Service Bulletin

No. : MZ08-056

Model: CD5003

Subject: Power PWB Modification

POWER PWB ASSY

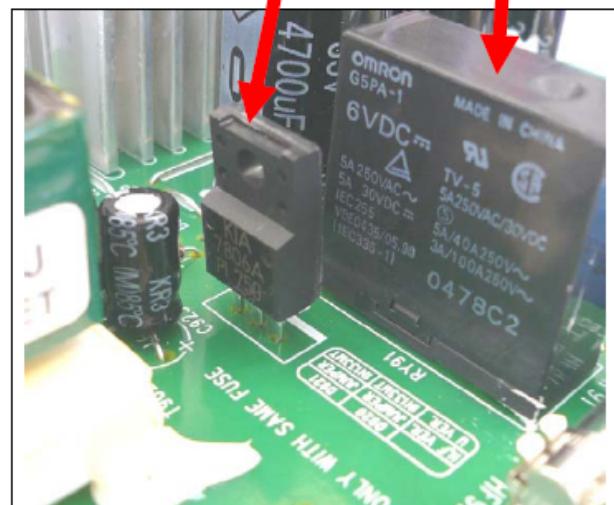
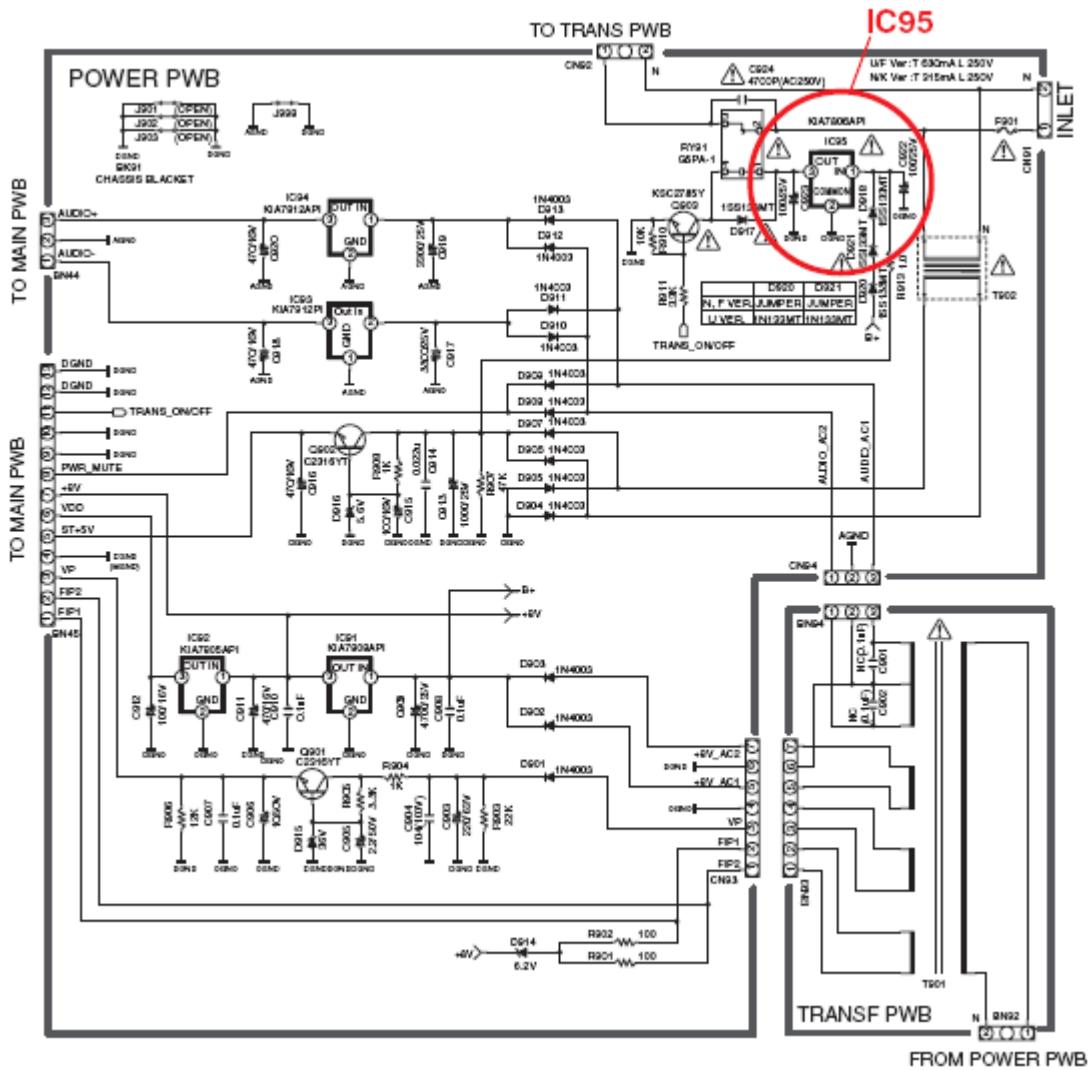
Old: POWER PWB No. CUP12097Z-3
 New: POWER PWB No. CUP12097Y-3

IC95
 to be additionally mounted

RY91
 changed

1. Power PWB "PWB No.CUP12097Z-3" has been replaced with "CUP12097Y-3".
2. After replacing the board replace relay "POS.NO. RY01".
3. POS.NO. IC95 (IC) is to be additionally mounted.

Note: Please DO NOT apply this modification to the old PWB (CUP12097Z-3). It is not applicable to the old PWB.
